Los Angeles Regional Water Quality Control Board

**SUBJECT: REVIEW OF TECHNICAL DOCUMENTS PURSUANT TO CALIFORNIA
WATER CODE SECTION 13267**

**SITE: SKYPARK COMMERCIAL PROPERTIES (ASSESSOR PARCEL NO.
7377-006-906), 24701 – 24777 CRENSHAW BOULEVARD AND 2530,
2540, AND 2600 SKYPARK DRIVE, TORRANCE, CALIFORNIA (SCP
NO. 1499)**

FIGURE 1

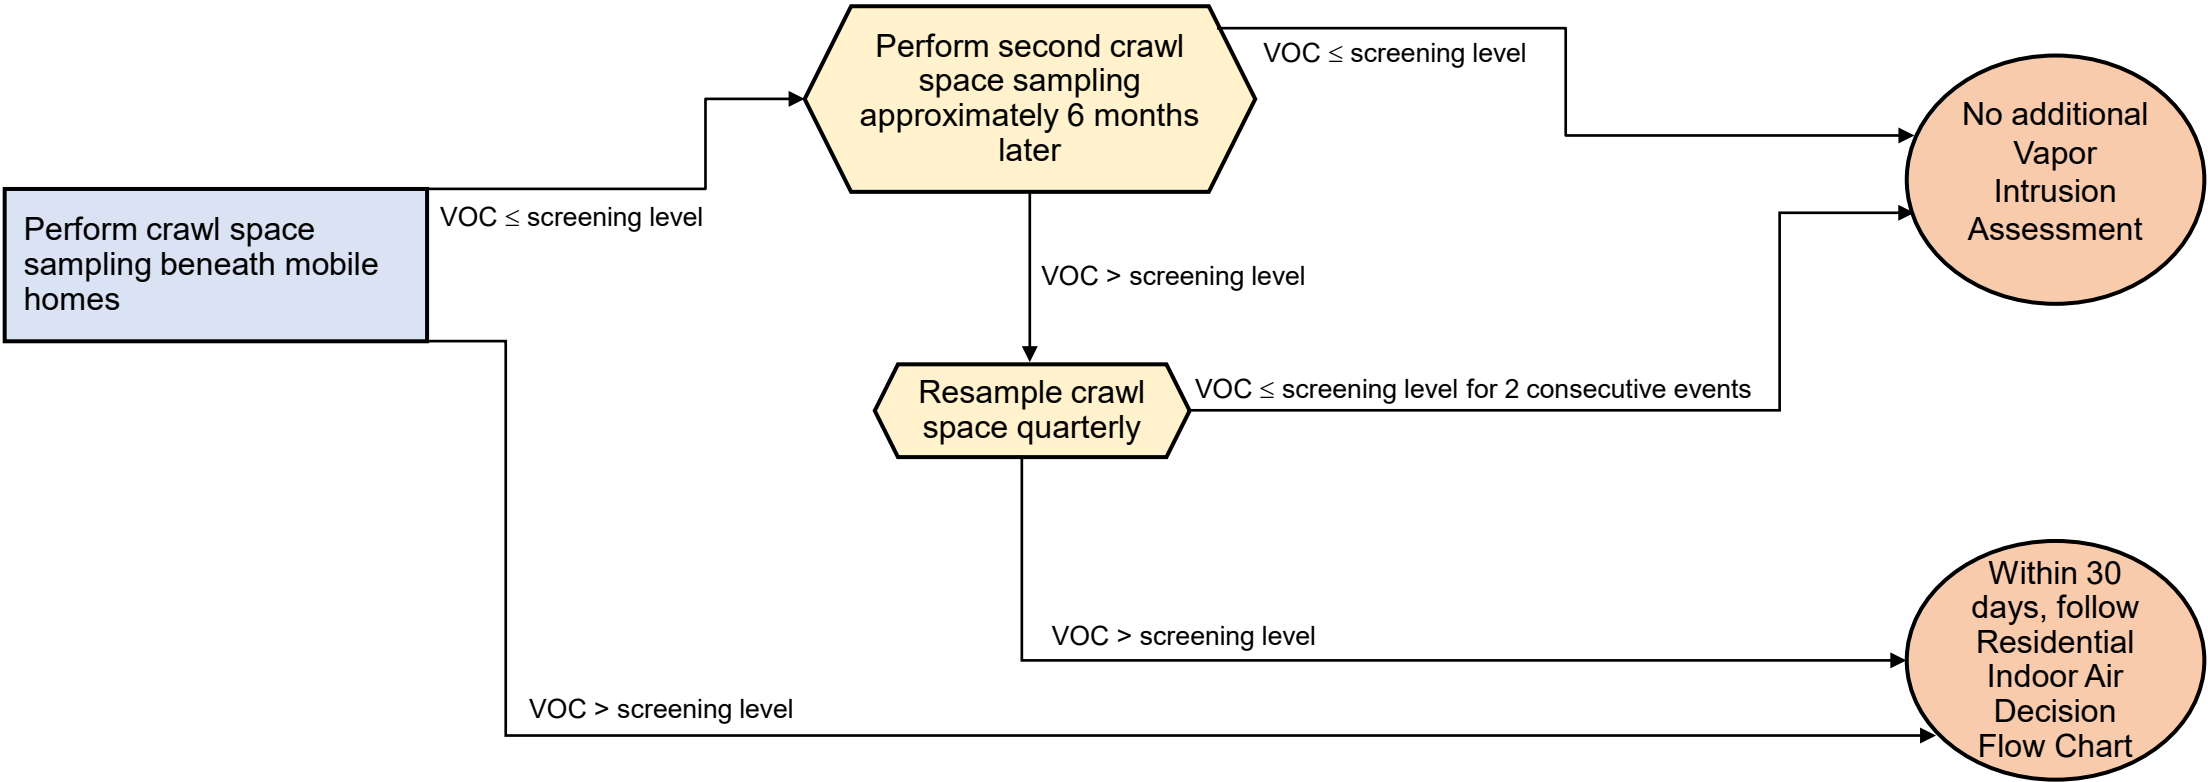
- a. If a volatile organic compound (VOC) of concern is detected above the screening level in the crawl space sample, and it has been determined that the source of the VOC is from the subsurface, then interim mitigation measures such as installation of air purifiers or ventilation should be performed. The “Mobile Home Decision Flow Chart” (see attached Figure 1) should be updated with this note and resubmitted to the Los Angeles Water Board by **December 7, 2020**.

FIGURE 2

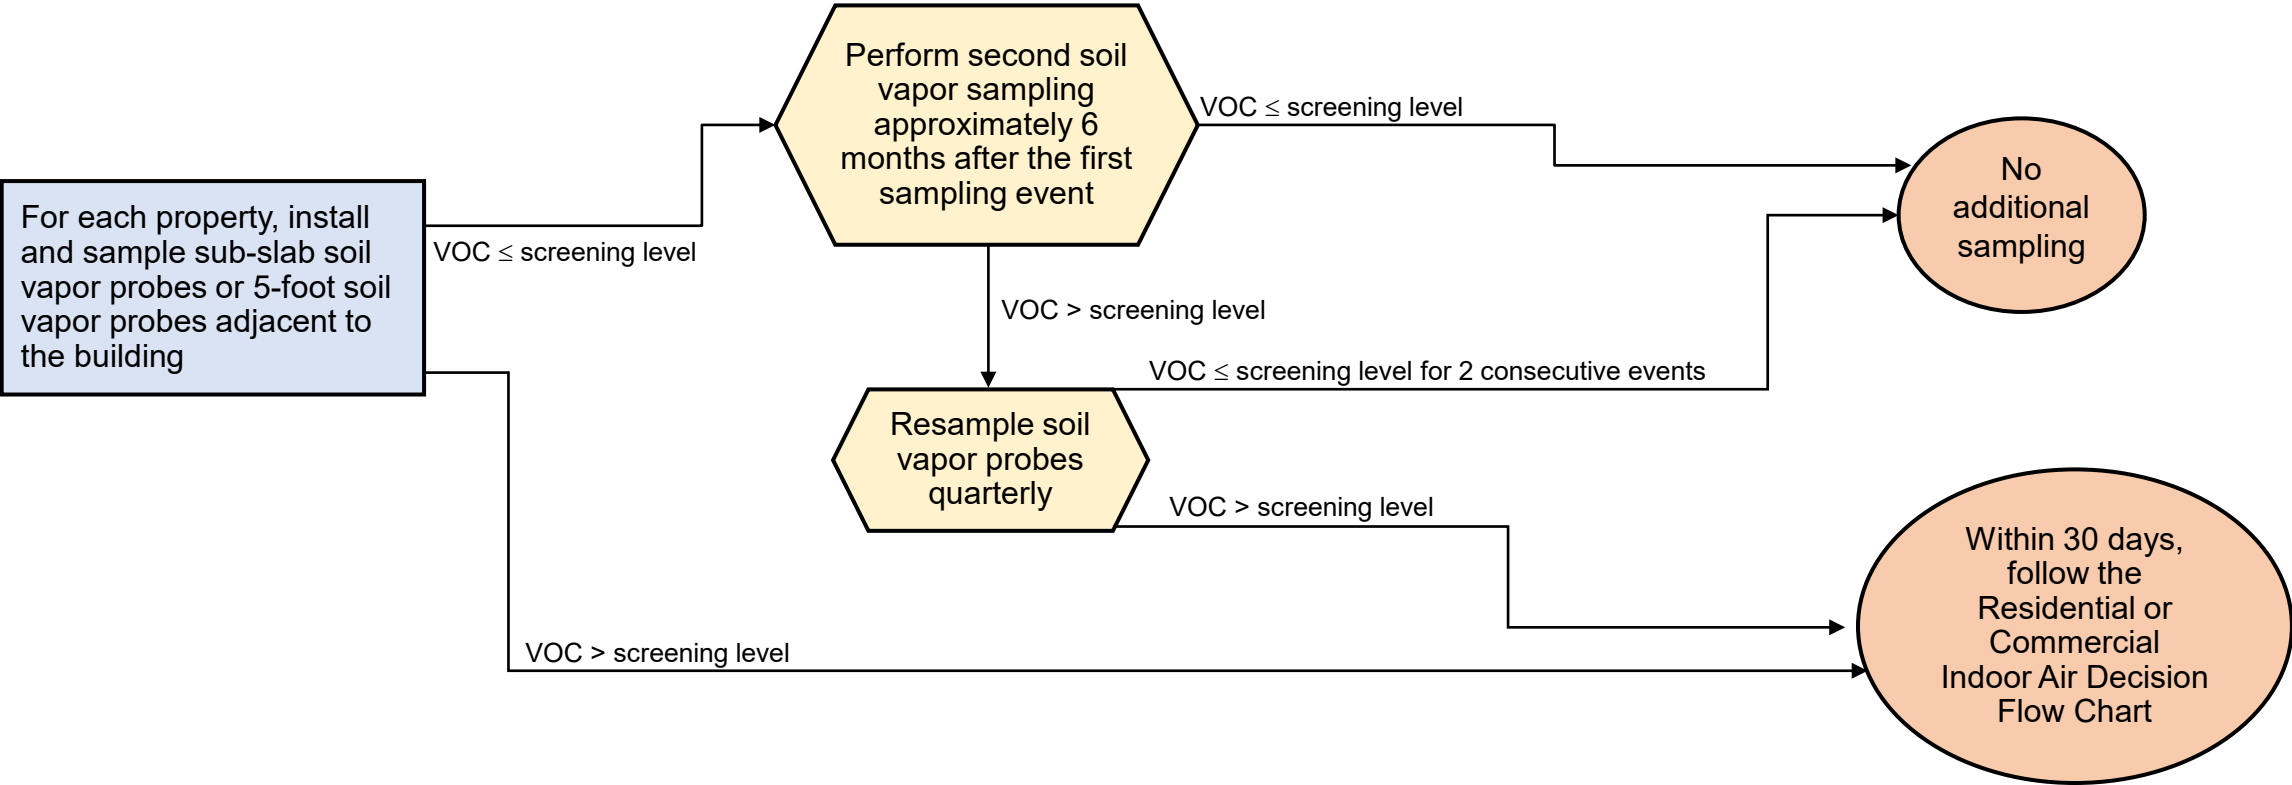
- b. If a VOC of concern is detected in sub-slab and/or soil vapor samples at concentrations that exceed the corresponding San Francisco Bay Regional Water Quality Control Board Environmental Screening Levels (SFRWQCB ESLs), then interim mitigation measures should be performed. The “Residential (Slab-on-Grade Foundation) and Commercial Soil Vapor Decision Flow Chart” (see attached Figure 2) should be updated with this note and resubmitted to the Los Angeles Water Board by **December 7, 2020**.

FIGURE 4

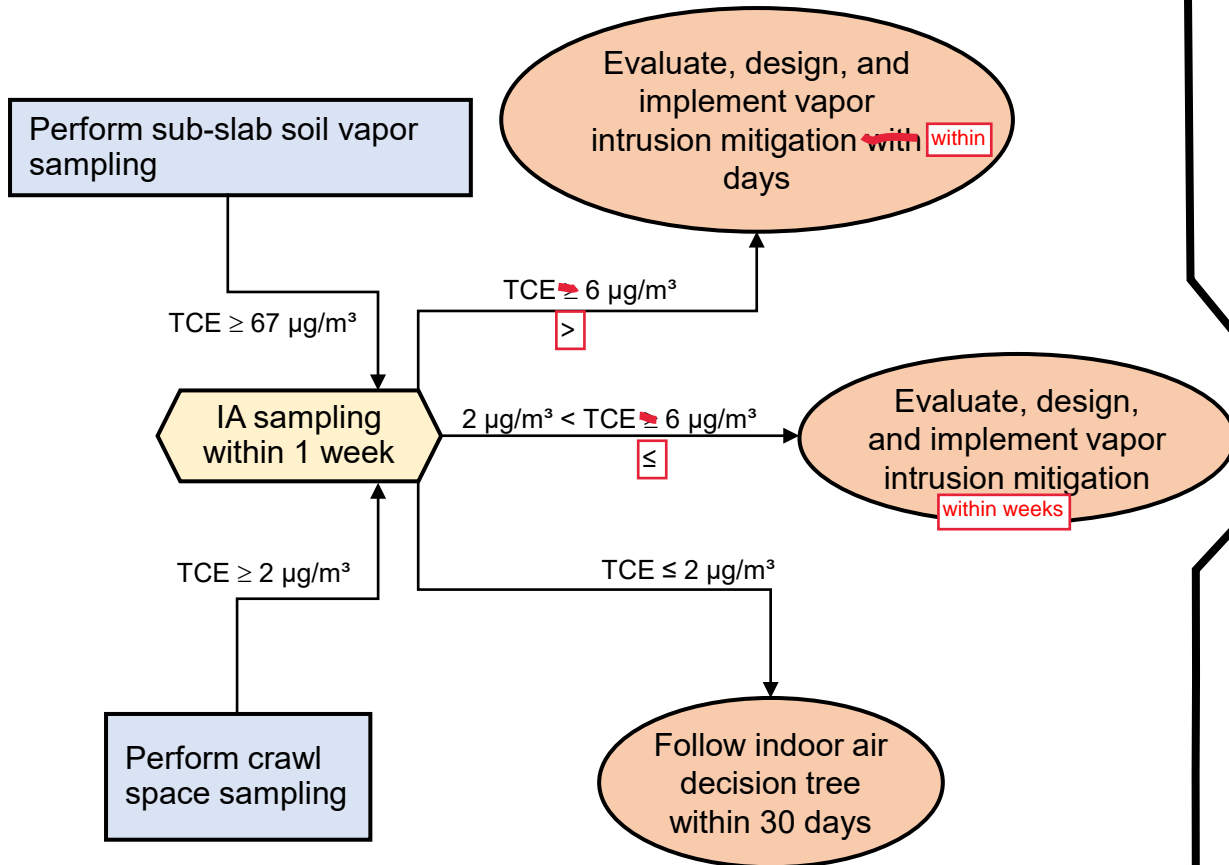
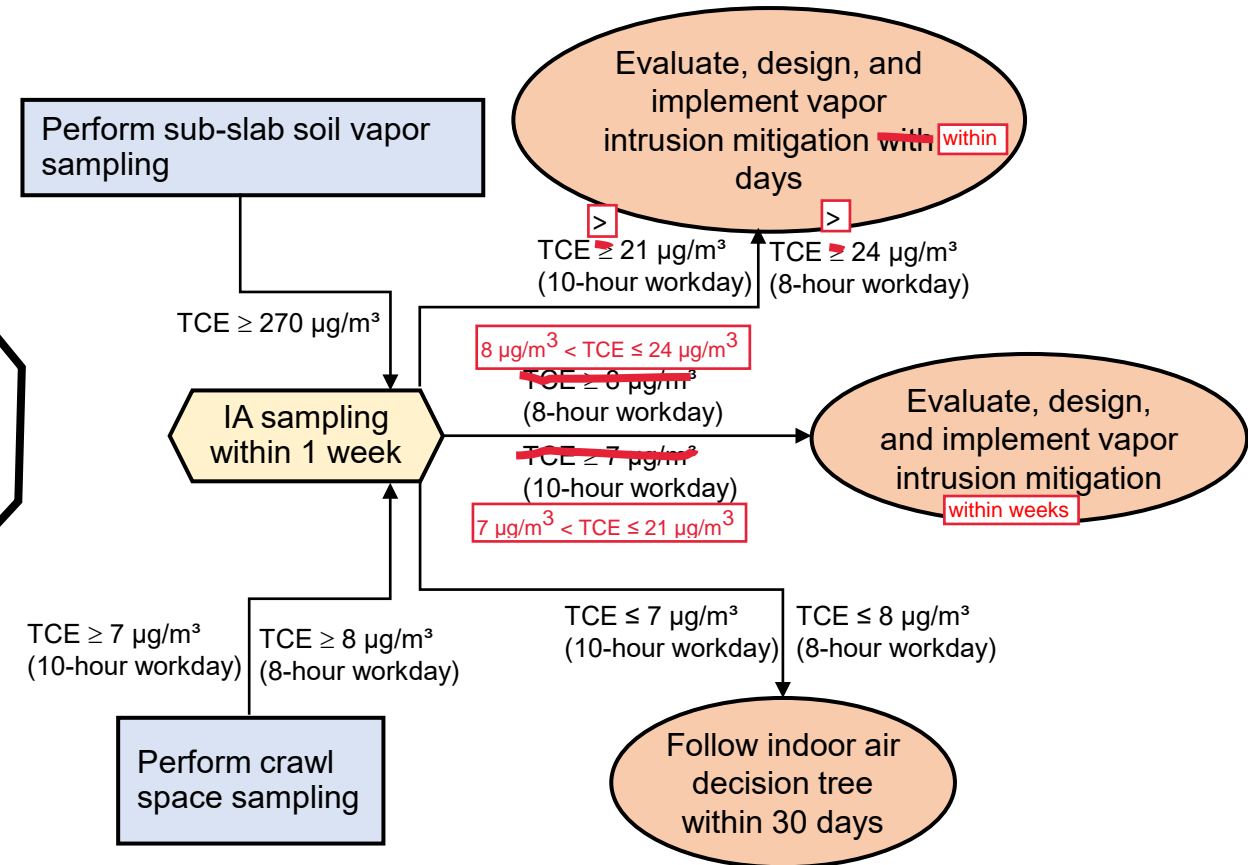
2. The “Accelerated and Urgent Response for TCE in Indoor Air Residential and Commercial Decision Flow Chart” did not adequately represent applicable guidance and response actions. The decision flow chart should be updated with the edits marked in red on the attached Figure 4 and resubmitted to the Los Angeles Water Board by **December 7, 2020**.
